ADDENDUM
NO. 3

April 17, 2026

**TRI-TOWNSHIP WANATAH SCHOOL
RENOVATION AND RELATED WORK
Wanatah, IN 46390**

This Addendum consists of Pages ADD 3-1 through ADD 3-4, and attached Addendum No. 3 from Gibraltar Design dated April 16, 2026 and consisting of 5 pages, replacement Specification Section 33 40 00 - Storm Sewage Systems, and 15 drawings.

1
ES102 ELECTRICAL SITE PLAN
1" = 50'-0"

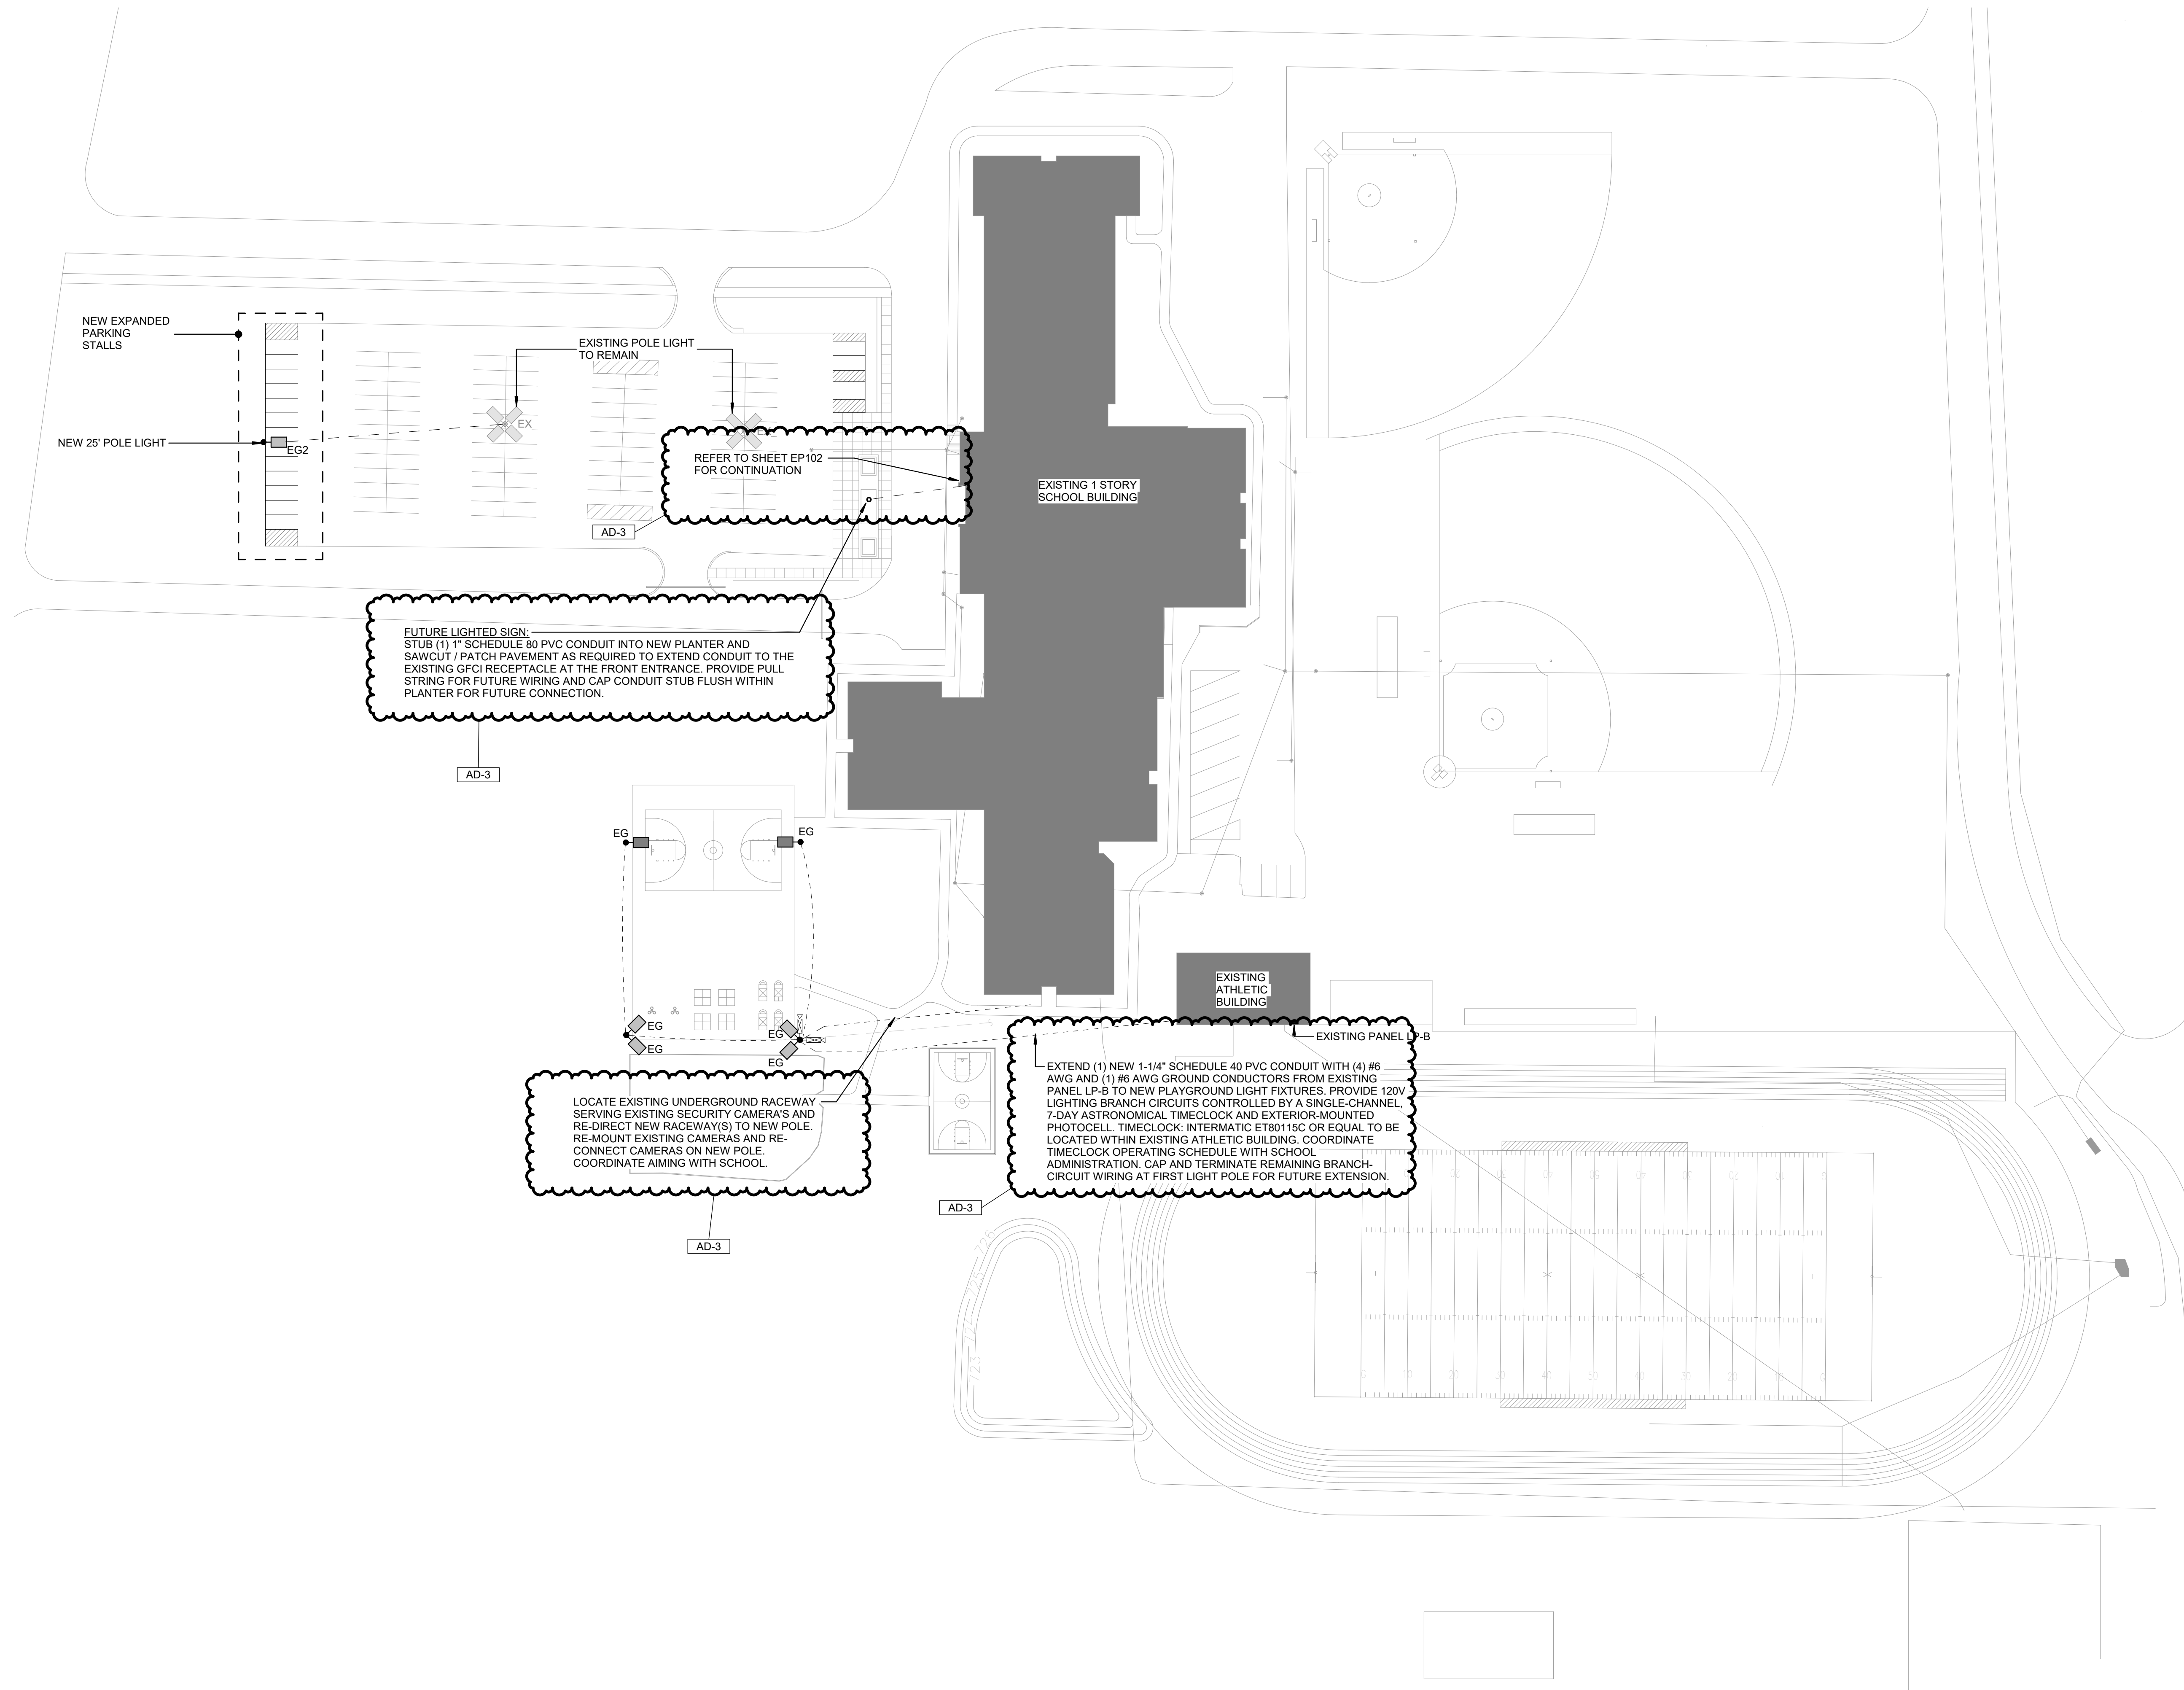
24. Sheet ES-102

- A. Refer to revised, full-size drawing, for Branch Circuit requirements to New Playground Lighting, included in this Addendum, for clarifications.

© GIBRALTAR DESIGN SHEET
B EP102

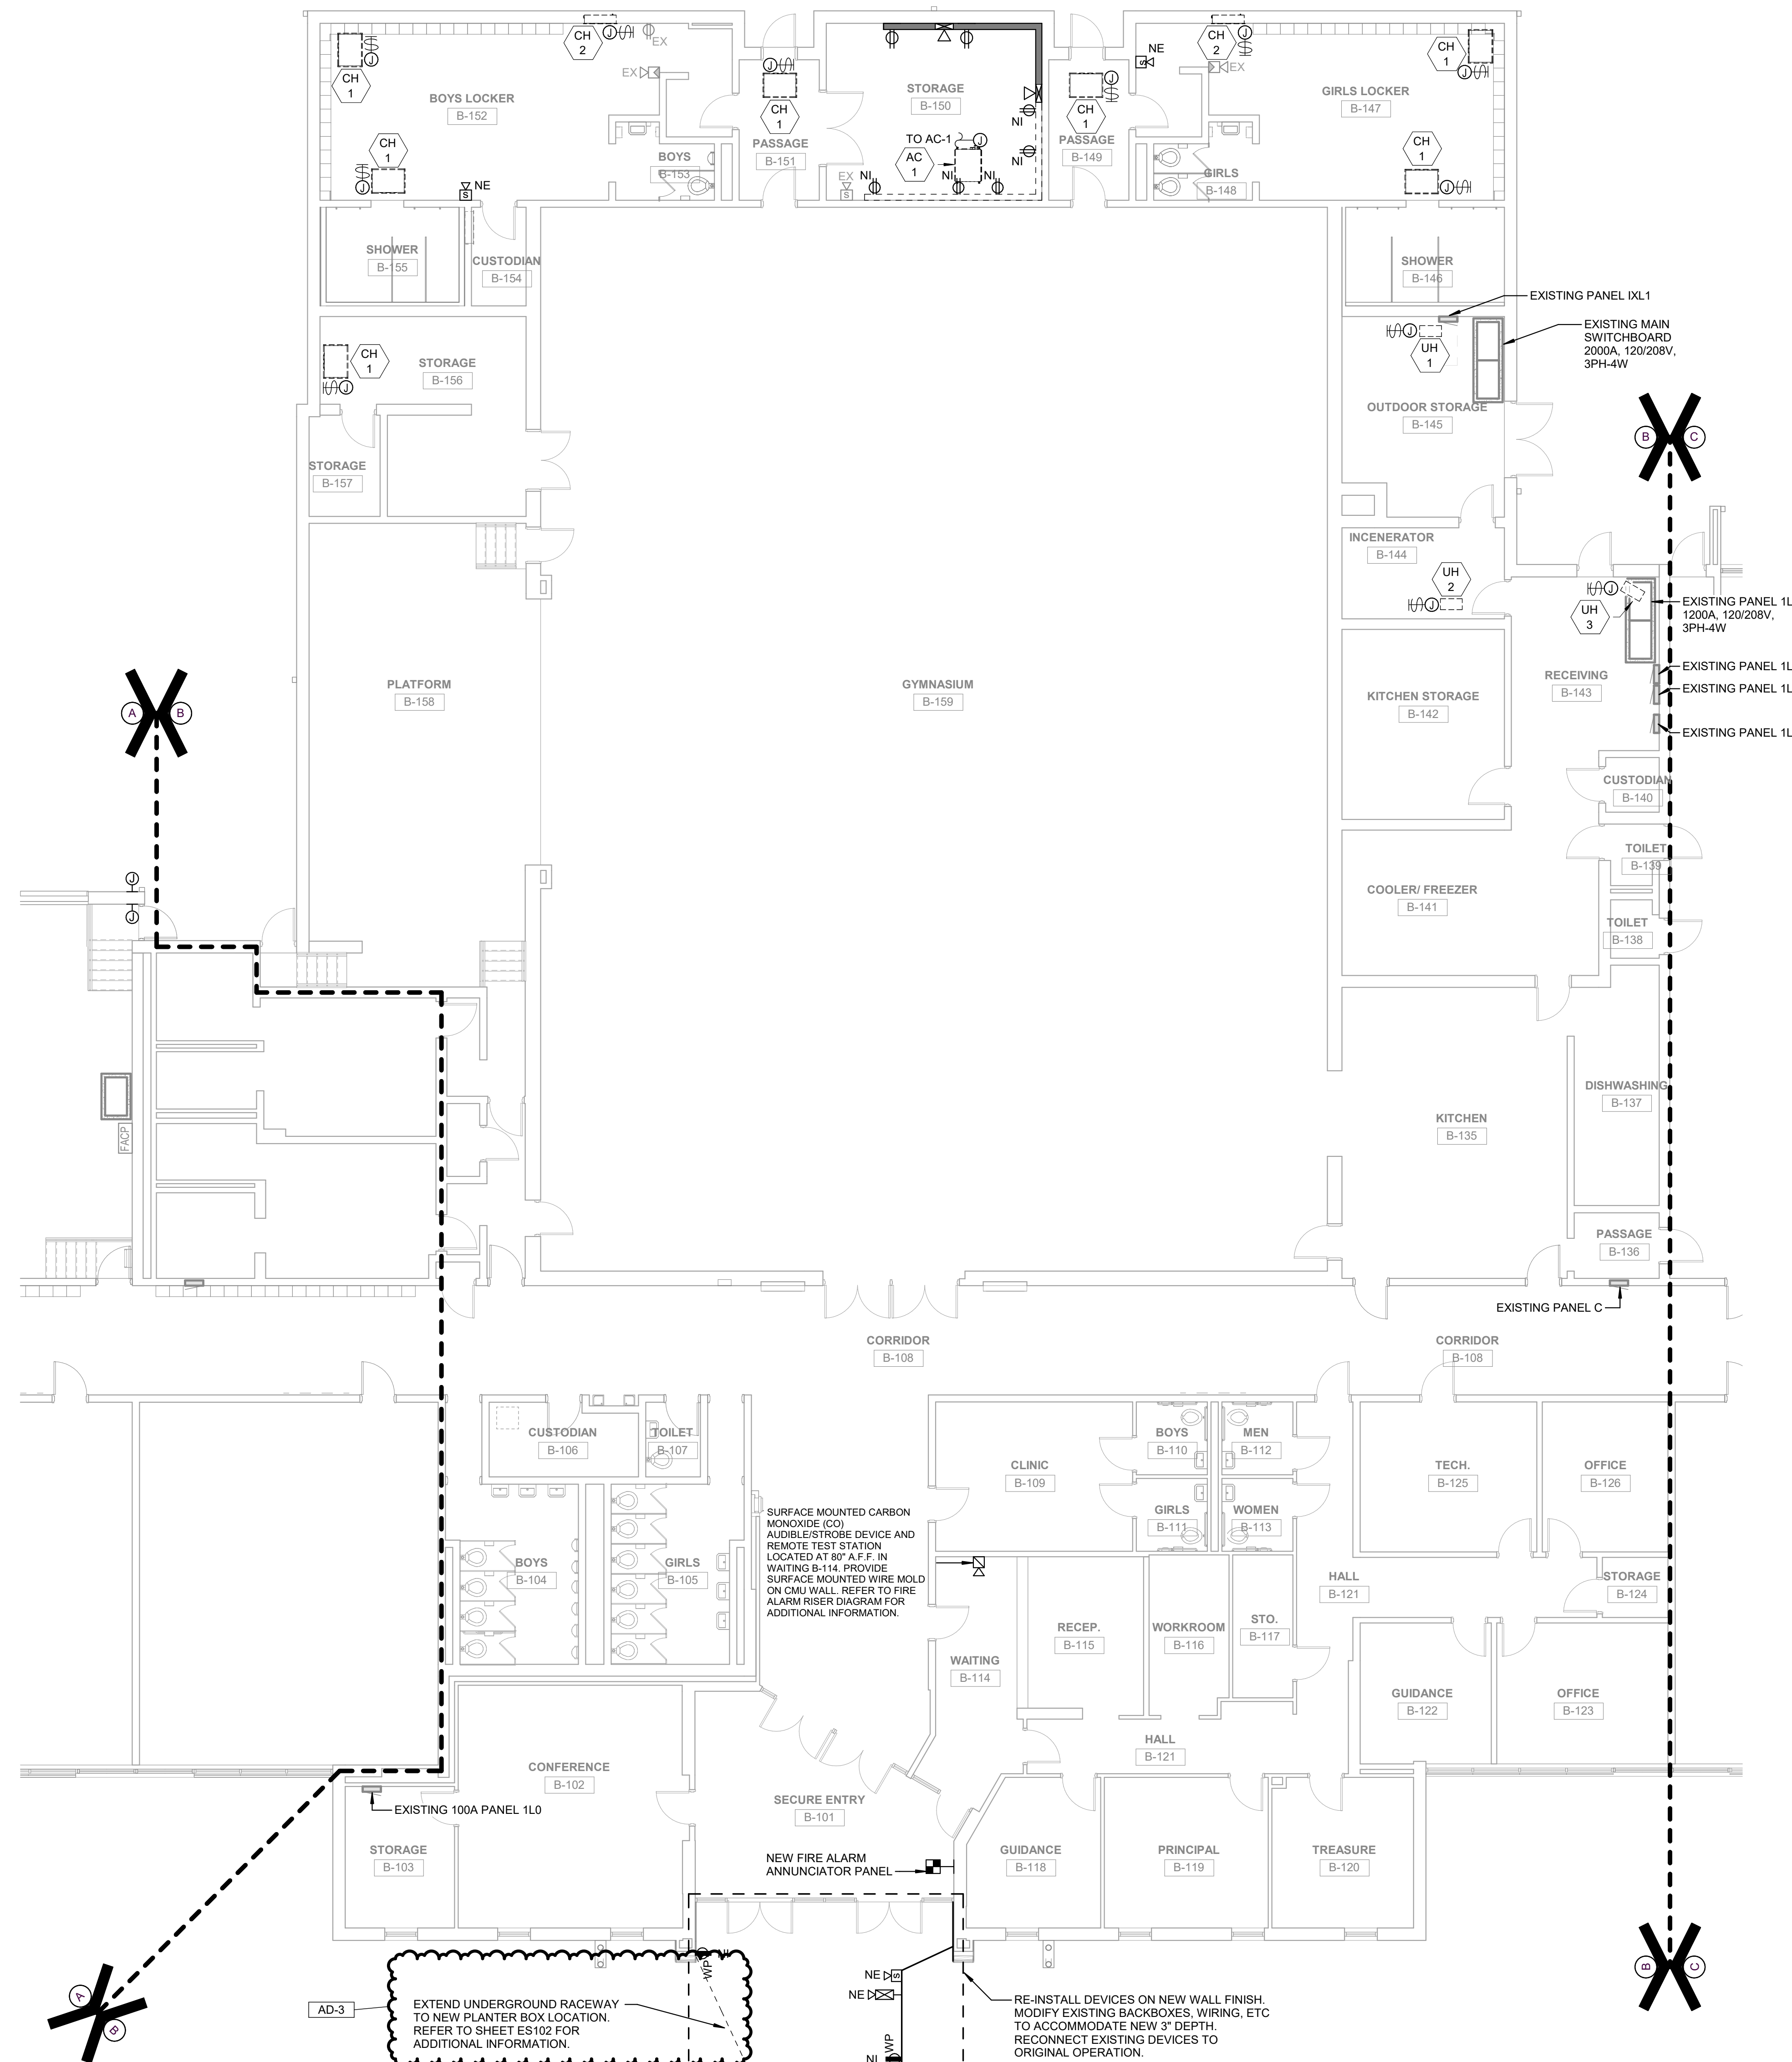
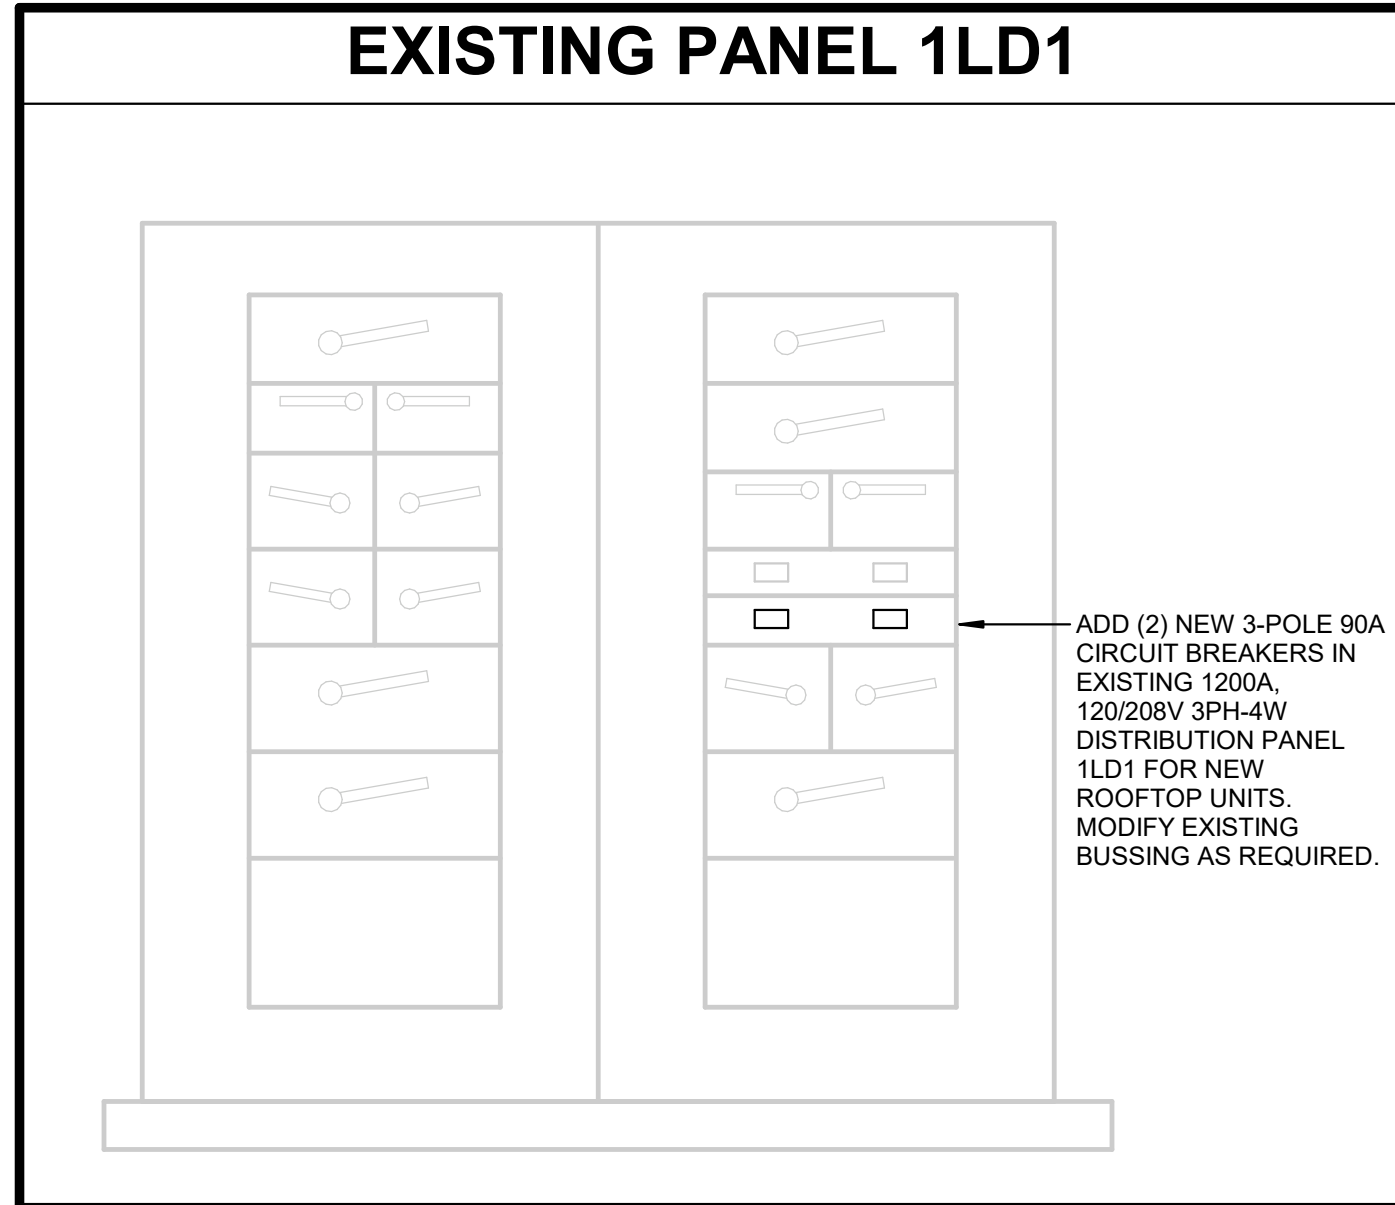
25. Sheet EP-102

- A. Refer to revised, full-size drawing, for added conduit for future lighted signage, included in this Addendum, for clarifications.
